IMPROVEMENT PLANS FOR ROSEVILLE ROAD - ARCADE CREEK BRIDGE REPLACEMENT

(PN: T15068500)

AS BUILT

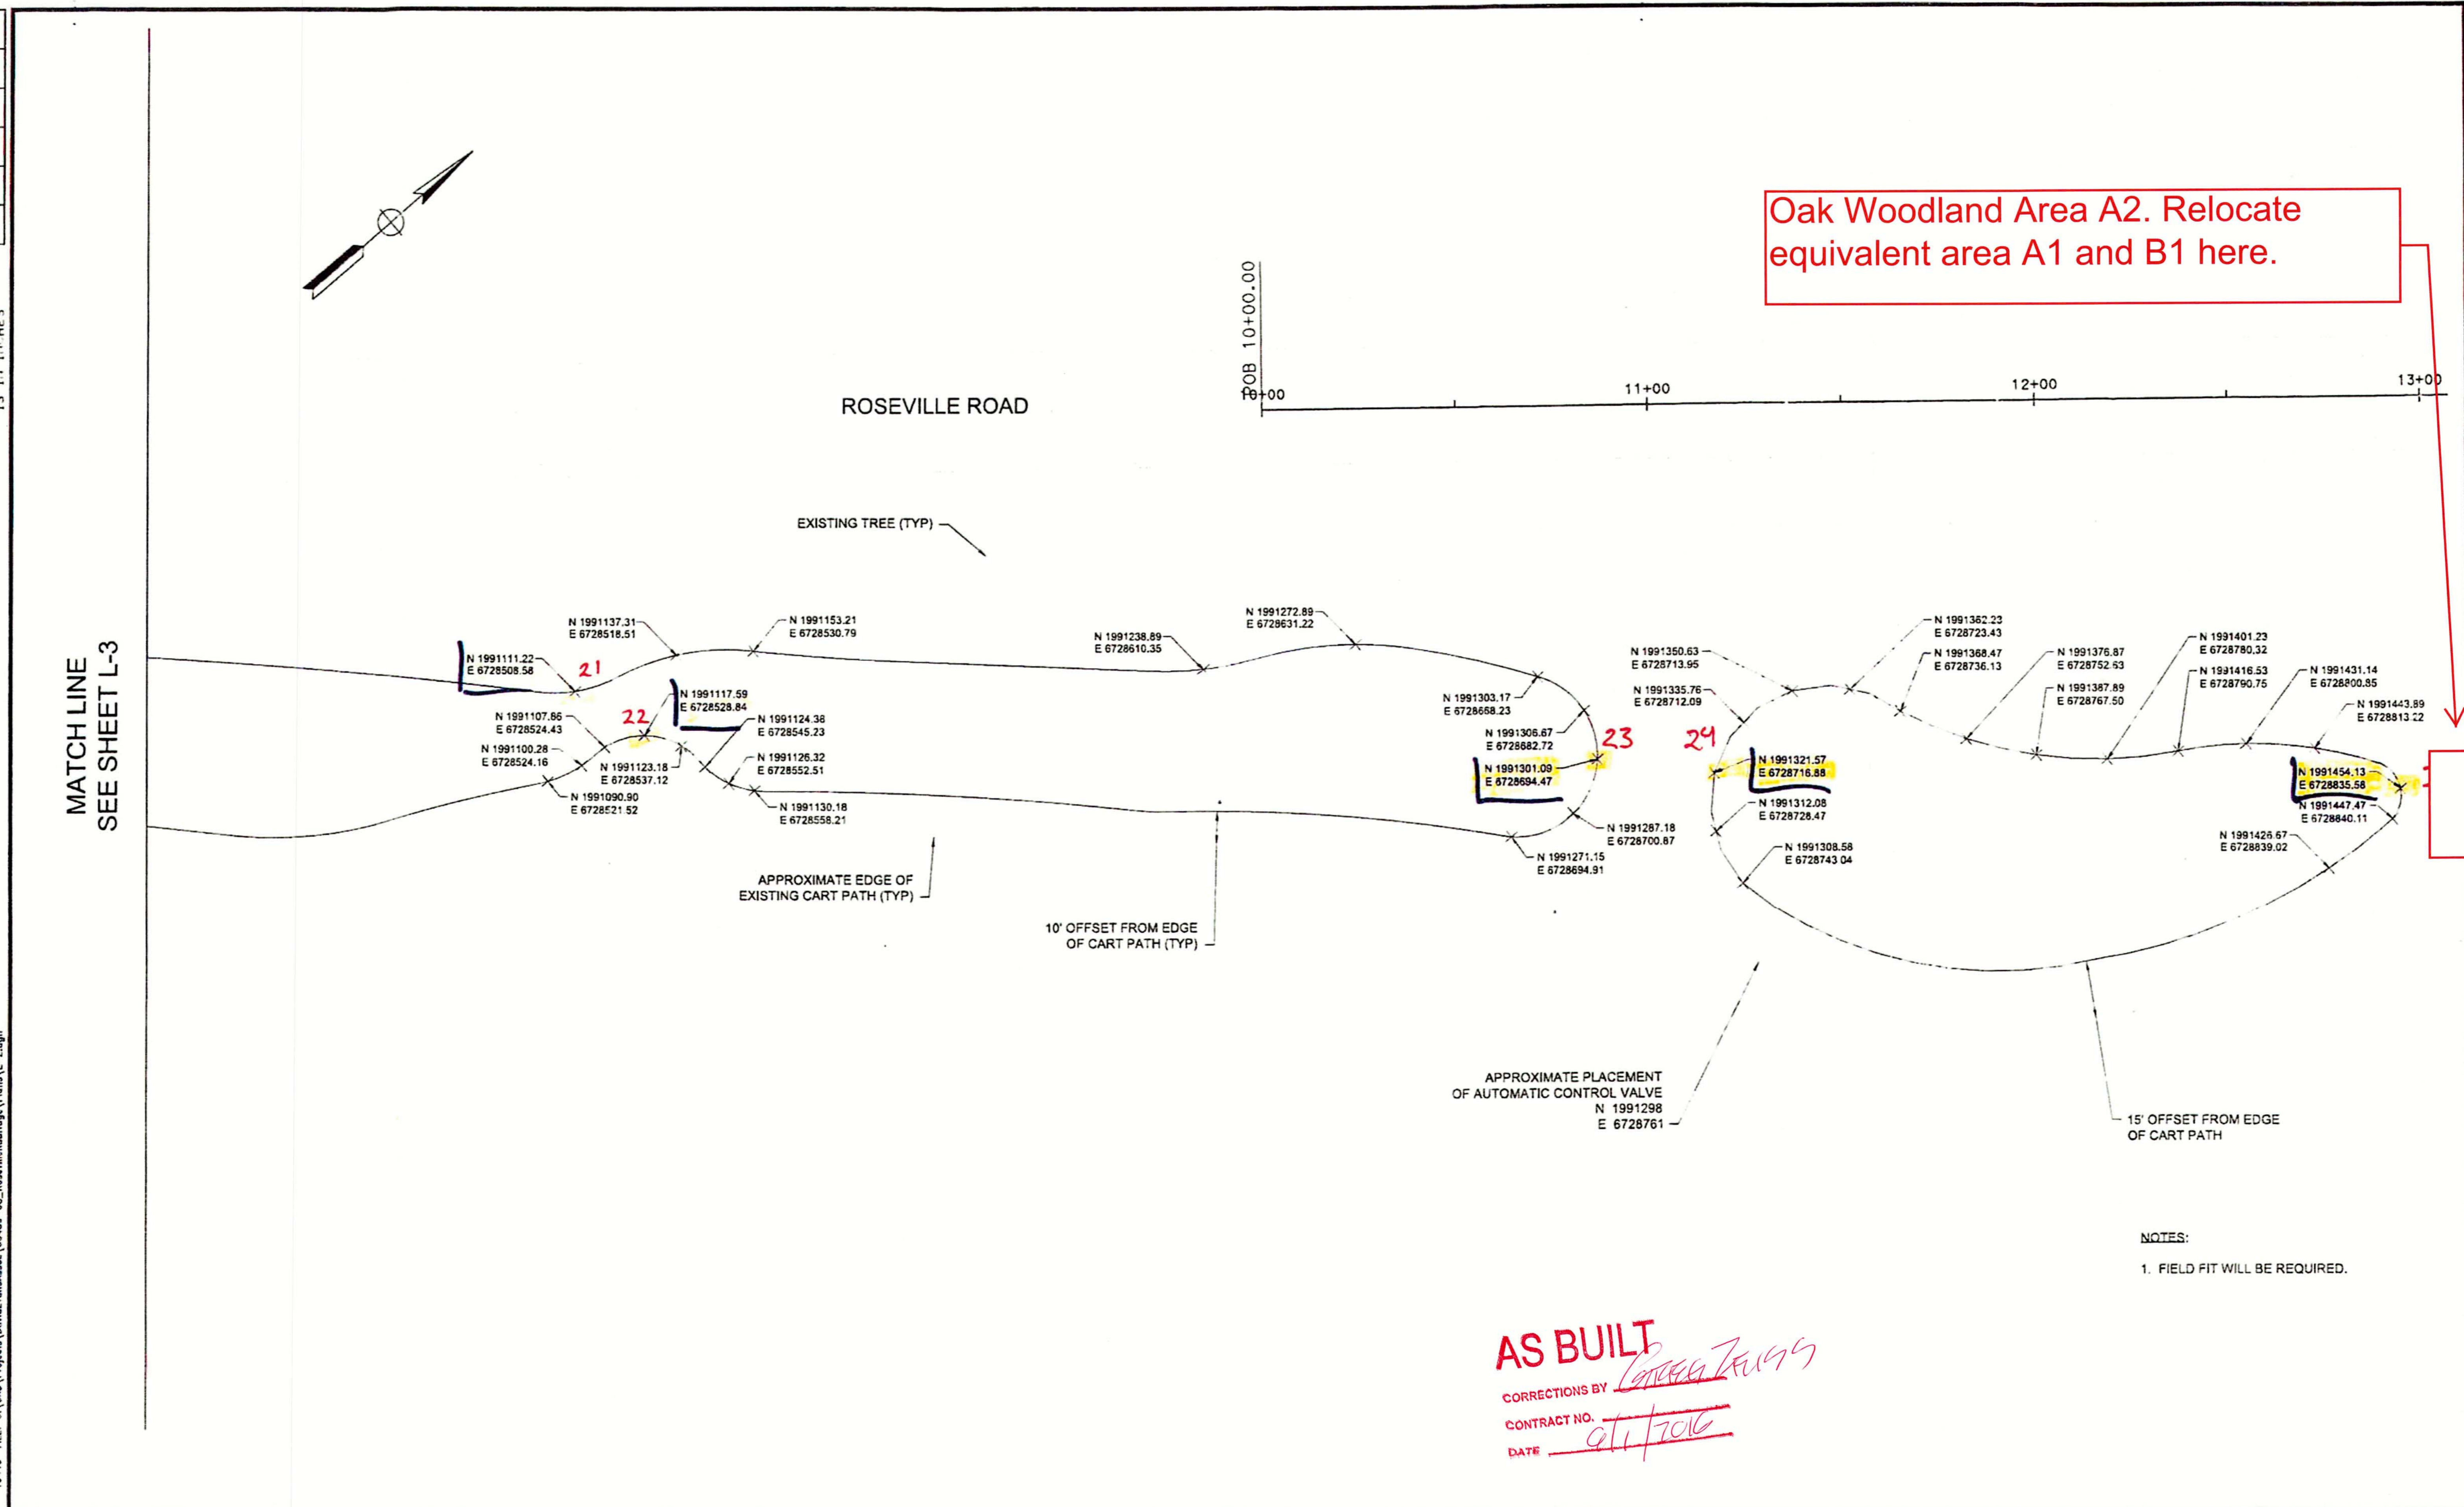
Oak Woodland Area A2. Relocate equivalent area A1 and B1 here.

IMPROVEMENT PLANS FOR
ROSEVILLE ROAD - ARCADE CREEK BRIDGE REPLACEMENT
LAYOUT PLAN - CITY MITIGATION SITE

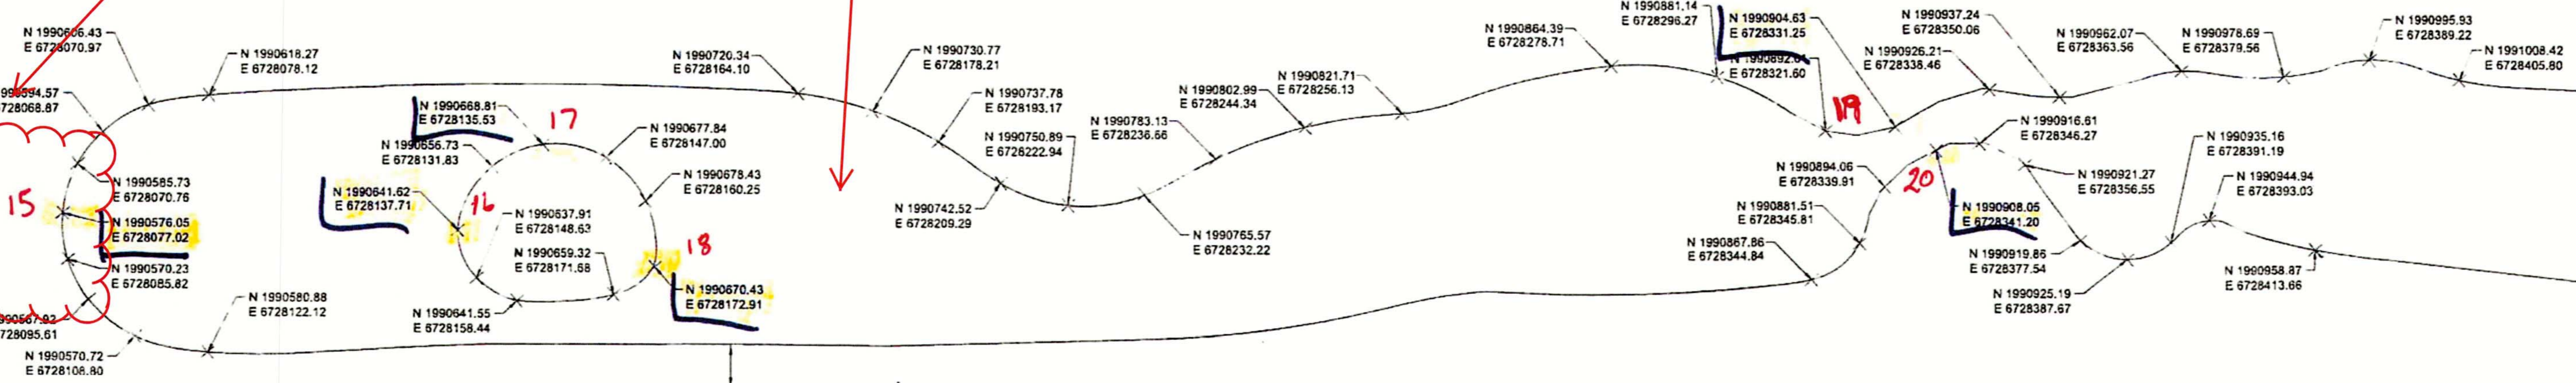
Area C1 Oak Woodland. If plants need to be relocated in this area in order to have access to existing irrigation facilities, then relocate to equivalent Area C2.
